To: Rodion Iwanczuk, Planner, Loudoun County Division of Community Information and Outreach

From: Wayne Lee, Purcellville Assistant Town Planner

**Loudoun County Public Schools
Special Exception Statement of Justification
Western Loudoun County High School (HS-3)
Fields Farm Property
June 29, 2006
Updated December 12, 2006
Updated February 15, 2007**

Responses to Purcellville's June 5, 2006 HS-3 Comments

Figure 10

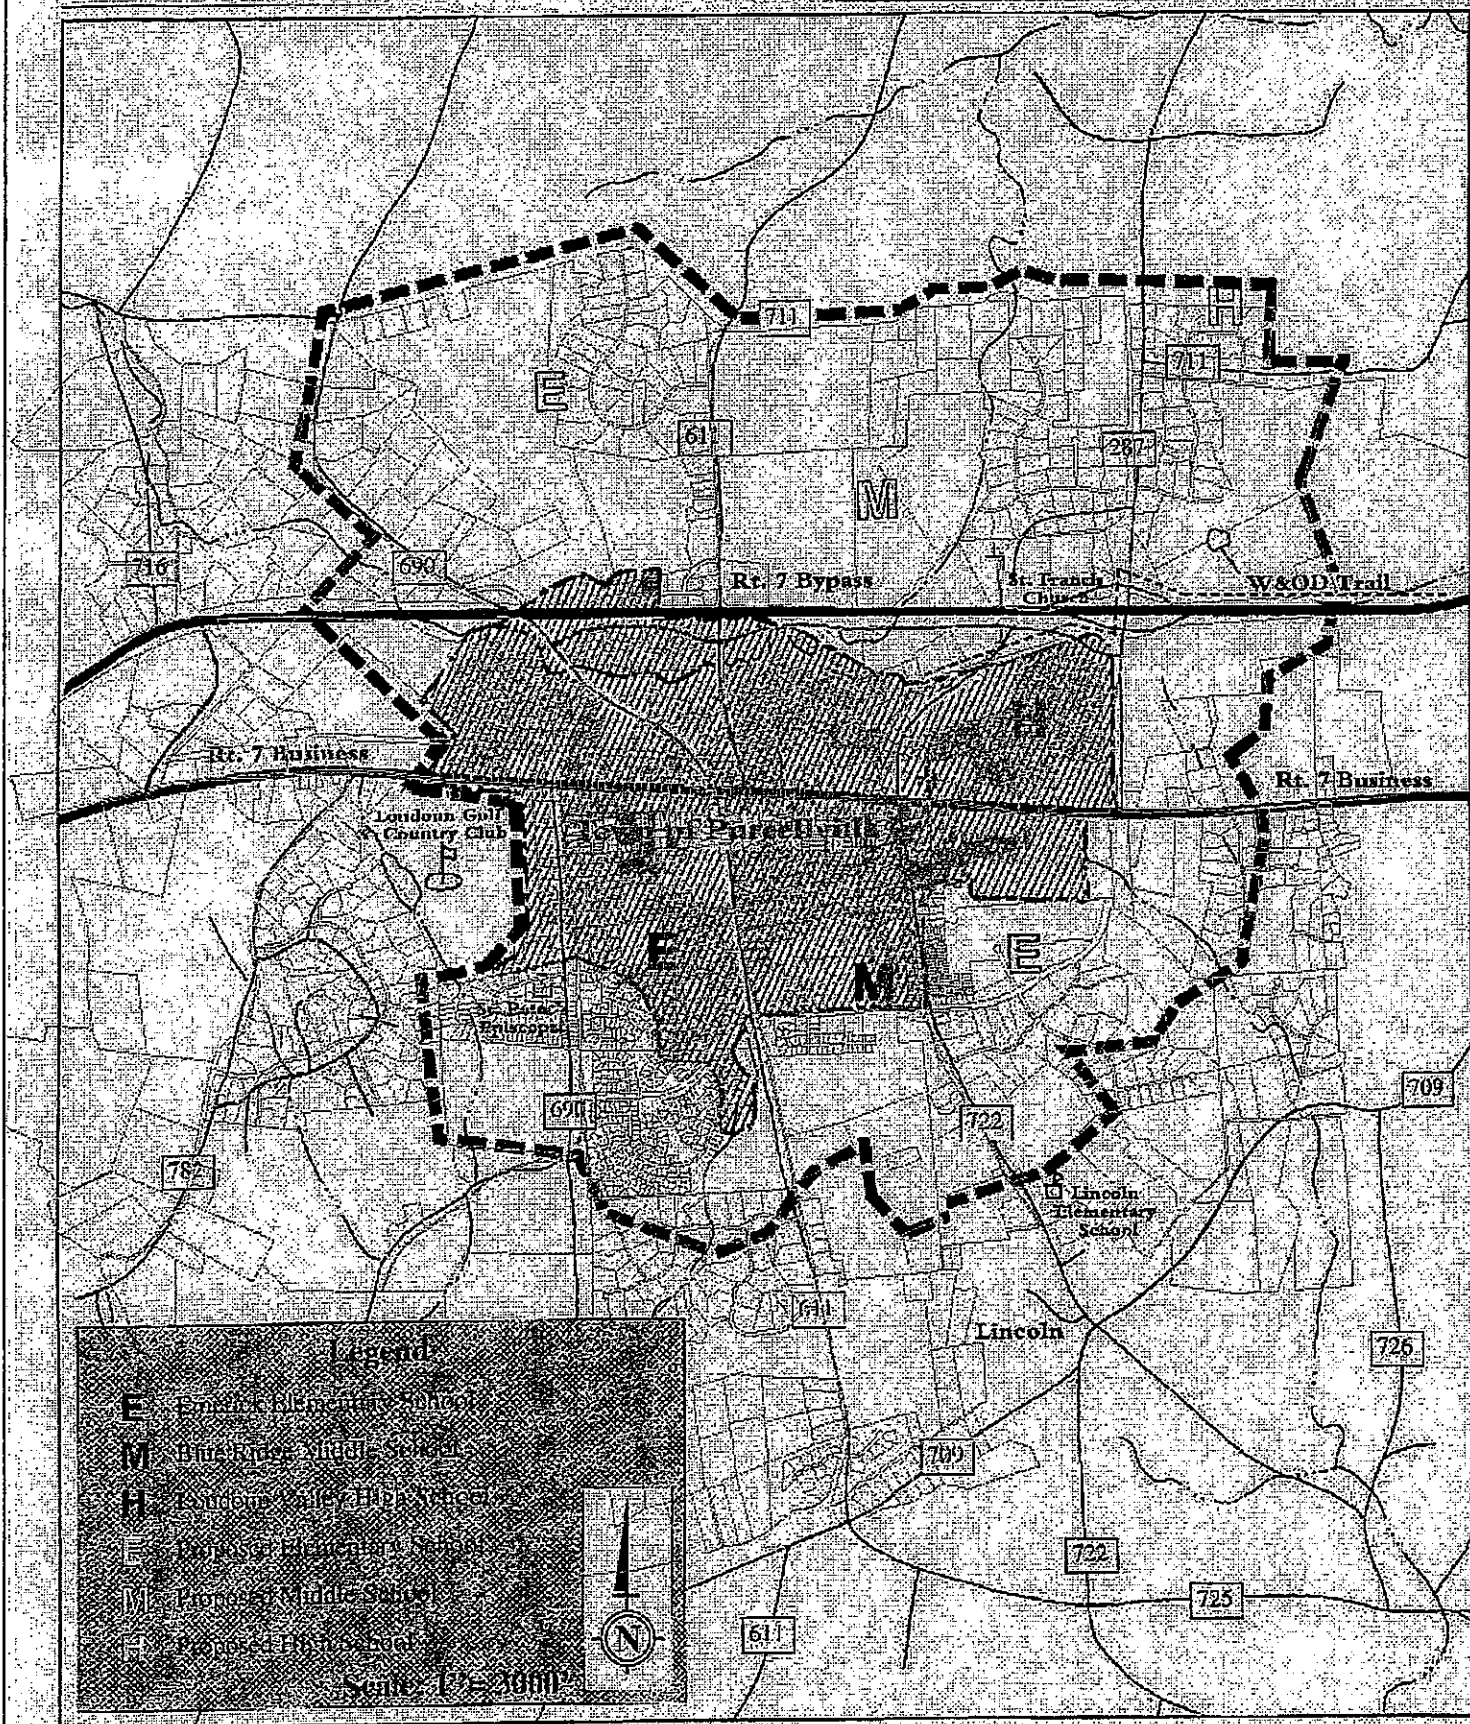
Figure 10 of PUGAMP is entitled "Existing and Proposed School Locations". The dashed line on that figure is the boundary of the PUGAMP area. There are general locations shown on Figure 10 for proposed elementary, middle and high schools (designated by an outline E, M and H, respectively). It is important to note that the proposed school sites were not arbitrarily placed on Figure 10 when the plan was adopted in 1995. The proposed high school was located along the Rt. 287 corridor due to its convenient access to the grade-separated interchange with the Rt. 7 Bypass and its location within the largest land holding at the time within the PUGAMP area (the Wright Farm, which was under single ownership and included approximately 484 acres on both sides of Rt. 287). Since the School Board sometimes receives donated school sites as part of proffered rezonings and Wright Farm was an area designated for permitted higher residential zoning in PUGAMP, the proposed high school on Wright Farm could potentially have been donated through a rezoning application covering this site.

The proposed Fields Farm location fronting on Route 690 is on the northwestern edge of the PUGAMP area in a completely different quadrant approximately two miles from the designated high school site on Figure 10 on the northeastern edge of the PUGAMP area east of Route 287. The entire width of the PUGAMP area on the north side of Route 7 is only approximately 3 miles.

As noted, there were also reasons the high school was located on the northeast side of PUGAMP, rather than on or near Fields Farm, which lacks access to the Rt. 7 Bypass. An elementary school is shown on Figure 10 approximately on Fields Farm, so the Town did not object to the County's location of Mountain View Elementary School on Fields Farm without a commission permit from either the Town or County Planning Commissions.

This text establishes that Figure 10 is the part of PUGAMP containing the location of proposed school sites. It also indicates that there will be a process involved if these preferred school sites are to be changed once certain other studies are completed.

The issue here is not whether or not Fields Farm is an appropriate location for a high school, but rather that there is a process that must be followed prior to locating a high school there, because a high school is not a "feature shown" on or in the vicinity of the Fields Farm site. The need for a specific process to change the preferred school locations was noted above and is further specified on page 58 in the Phasing portion of the PUGAMP Implementation Chapter (also referenced on PUGAMP page 48 cited above). This text, paragraph #3 of page 58, states:

One way would be to amend the PUGAMP plan, which is the Town and County comprehensive plan for the PUGAMP area, to change Figure 10 to show a high school on Fields Farm. This would require recommendations by both the County and Town Planning Commissions and approval by both the Town Council and the Board of Supervisors, in accordance with the Town/County Annexation Agreement, relevant State law and Town and County comprehensive plan amendment procedures.

general vicinity in which proposed schools may be located within the Urban Growth Area. Figure 10 depicts a new high school north of the Town. The policies of PUGAMP recognize that there will be a need for additional schools and state that The Town of Purcellville will generally be the preferred location for new public facilities unless a suitable site is not available in the Town (Policy #2 under Public Facility and Services Polices). The text also recognizes the need to re-evaluate school needs and the preferred school locations. Since the adoption of PUGAMP, subdivisions have been built north of Route 7 in the general area where the symbol was depicted for the new high school. The general location depicted for the proposed high school within the Urban Growth Area supports the Fields Farm site; the policies recognize the school need and the potential to adjust the general location. In sum, the proposed high school at Fields Farm site is consistent with the general location shown in PUGAMP as well as the identified need of the PUGAMP policies.

Figure
1

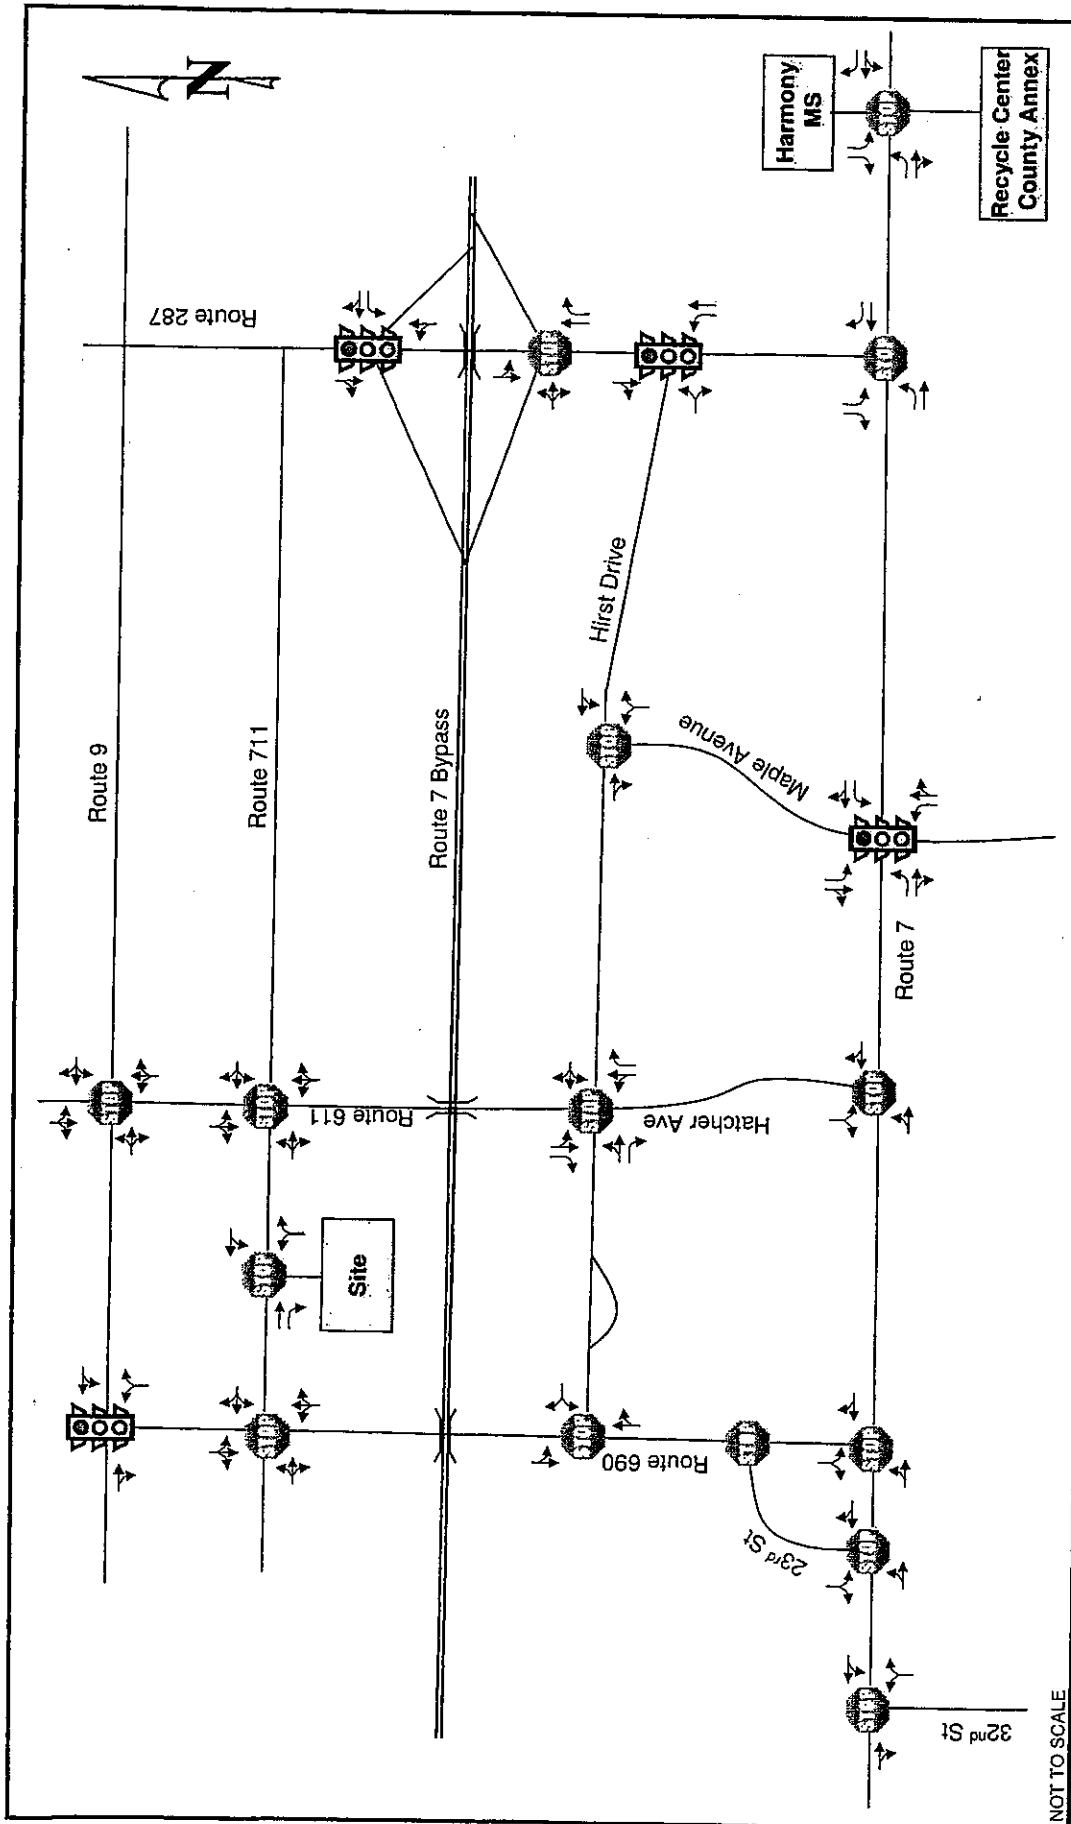
Comment 11: It would be helpful to show a graphic, similar to Figure 2a, depicting the existing lane designations and which of the study area intersections are signalized.

11. It would be helpful to show a graphic, similar to Figure 2a, depicting the existing lane designations and which of the study area intersections are signalized.

Comment 11: It would be helpful to show a graphic, similar to Figure 2a, depicting the existing lane designations and which of the study area intersections are signalized.

Response: Figure 1 (attached) provides a graphic illustrating (1) which intersections were analyzed, (2) the type of traffic control present at each location, and (3) the existing roadway geometrics.

Response: Figure 1 (attached) provides a graphic illustrating (1) which intersections were analyzed, (2) the type of traffic control present at each location, and (3) the existing roadway geometrics.

**Fields Farm High School
 ITE Site Traffic Volumes
 Purcellville, Virginia**

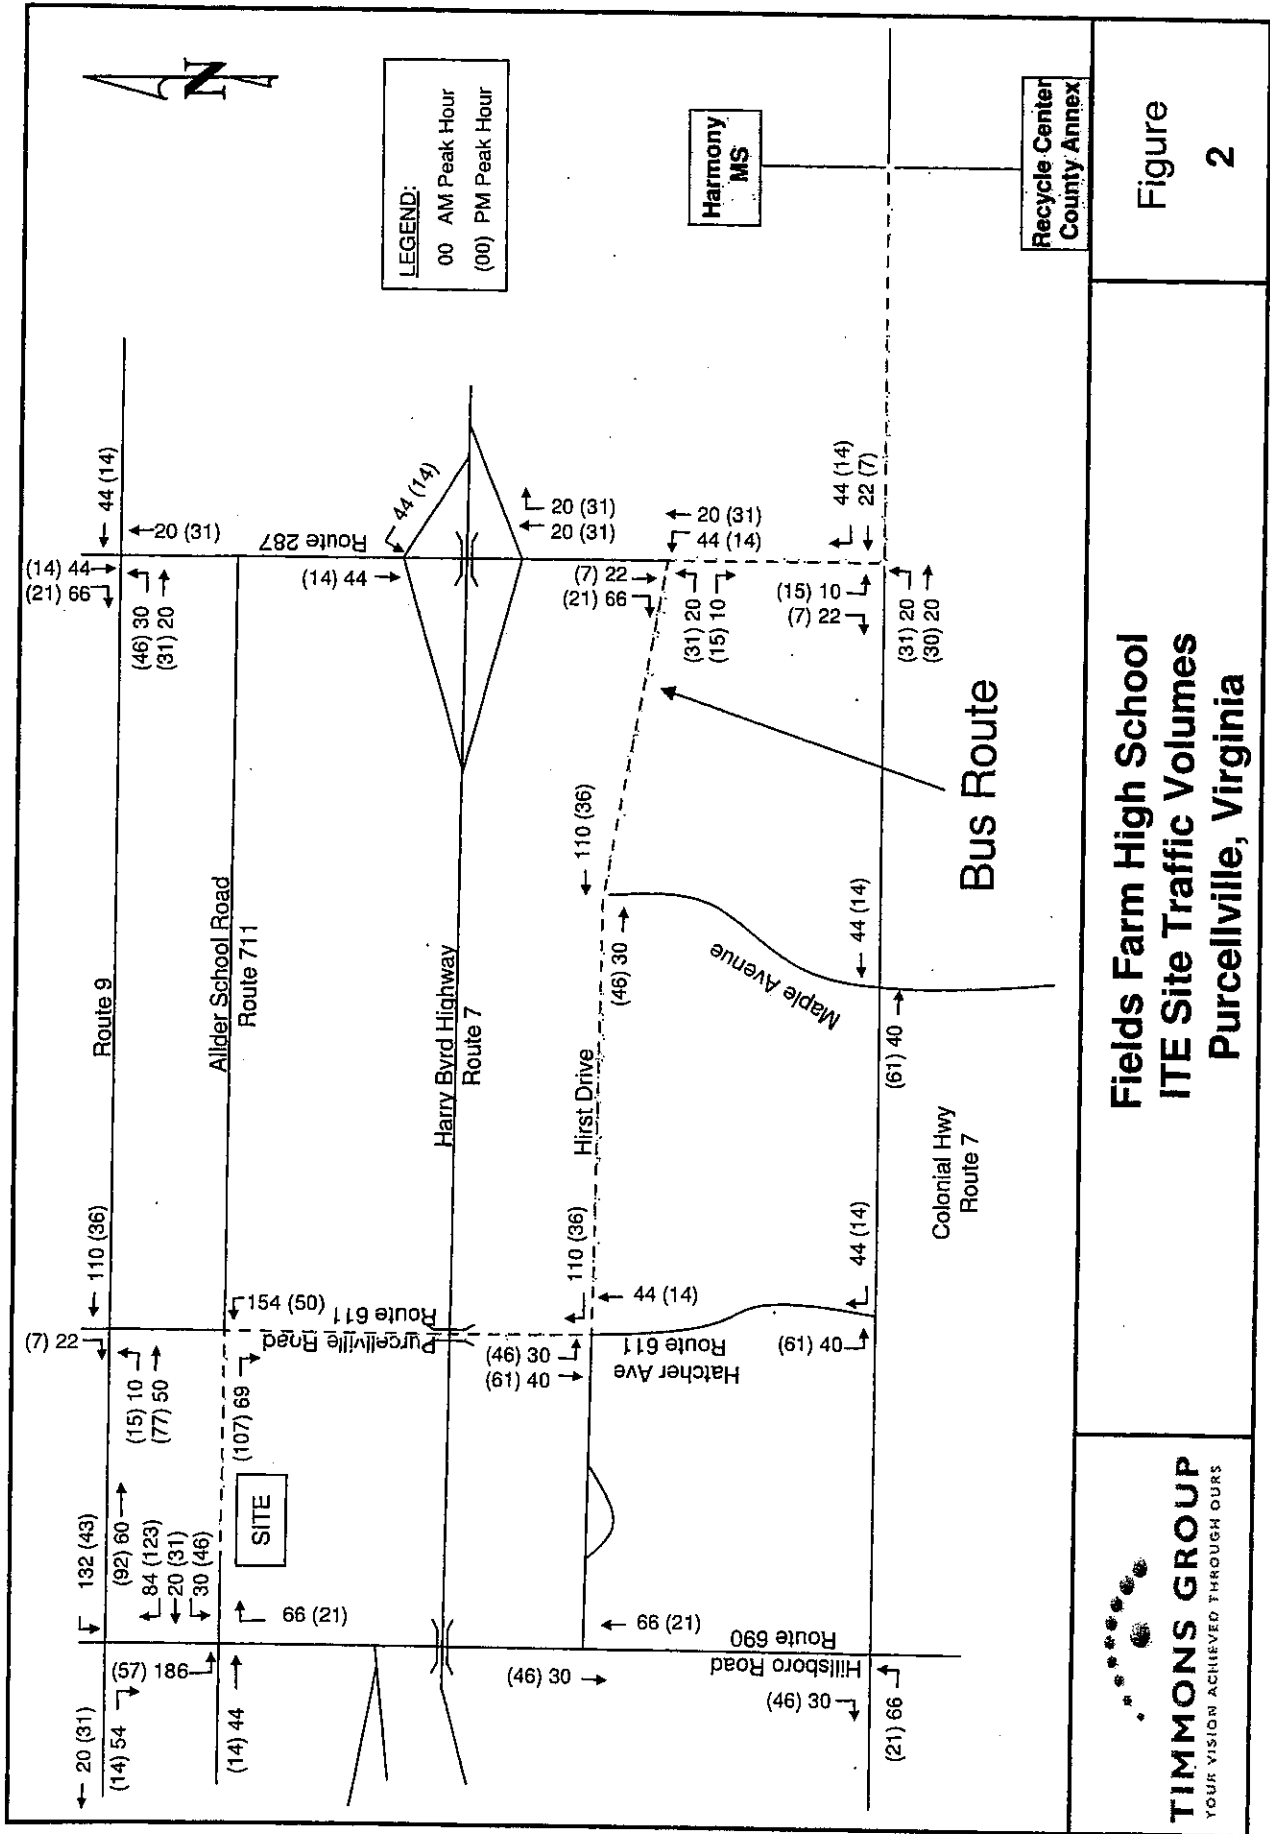
Comment 13: Trip generation appears to be reasonable, but it might be helpful to supplement the ITE trip generation equations with local data from other Loudoun County high schools. This area's socioeconomic demographic is predominantly affluent and it would be expected that there would be more vehicles per household, which could result in a higher trip generation rate for students.

Comment 17: It would be helpful to show a separate directional distribution for projected bus traffic. Are bus routes factored into total traffic? How about probable routes faculty and staff will take?

The original site-generated traffic estimates are shown on Figure 2 (attached)

Response: It is anticipated that bus traffic will follow the route highlighted on Figures 2 and 3 (attached); this information was also shown on Figure 4 in the original traffic study. Bus routes were taken into consideration with regard to traffic flows and operations. The remaining site traffic was distributed based on the location of the student body within the attendance zone.
